**Re: Columbia Precinct Stage 2 – Revised Urban Design Review**

Further to Architectus' engagement by JQZ to provide urban design advice and review for the proposed development at 11-17 Columbia Lane Homebush (the site), this letter provides Architectus' review of the current architectural plans (MPA Issue D, 15/7/2020) and landscape plans (Clouston Associates Issue F 16/7/2020) with particular regard to Council's letter 22 May 2020 following the proposal's review by the Sydney Eastern Planning Panel.

*Example image (9:45am overshadowing, MPA overshadowing analysis) showing the leading edge of the northern tower overshadowing part of the eastern edge of Building C at 14-16 Station Street (behind).*

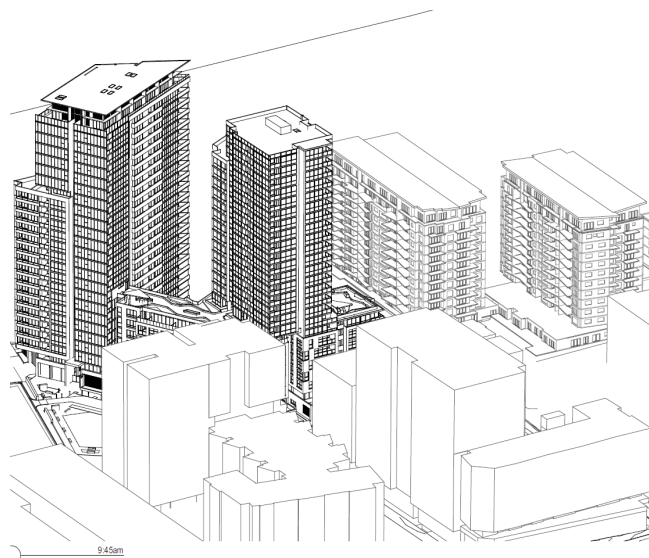
Plans for the existing buildings to the southwest of the site (14-16 Station Street) have been obtained since feedback from the Panel and Council and the design has been tested against these and amended to improve this interface fundamentally through:

- Lowering of the height of the north western wing of the design
- Amending the tower floorplate to 'cut' the leading edge of shadowing.

The revised impact on the sites at 14-16 Station Street is a reduction in units achieving 2 hours sun access in midwinter between 9am-3pm of 21 units, from 75 units of 109 (69%) to 54 units (50%). None of these units are reduced to below 1 hour of sun access. These are generally the southeast units of the proposed development and the shadow is caused by the leading edge of the tower (See image below). The impact is consistent with the ADG's Objective 3B-2 "Overshadowing of neighbouring properties is minimised during midwinter" as one of the key organising principles of the design has been to ensure no taller built form in the northwest corner of the site to minimise this overshadowing. In particular the following aspects of the ADG's design guidance around this issue have been followed:

- "If the proposal will significantly reduce the solar access of neighbours, building separation should be increased beyond minimums contained in section 3F Visual privacy". The nearest point of the tower is approximately 44m from the closest point on 14-16 Station Street, almost double the typical ADG separation of 24m.
- "Where an adjoining property does not currently receive the required hours of solar access, the proposed building ensures solar access to neighbouring properties is not reduced by more than 20%" which the development complies with on a per-unit basis.
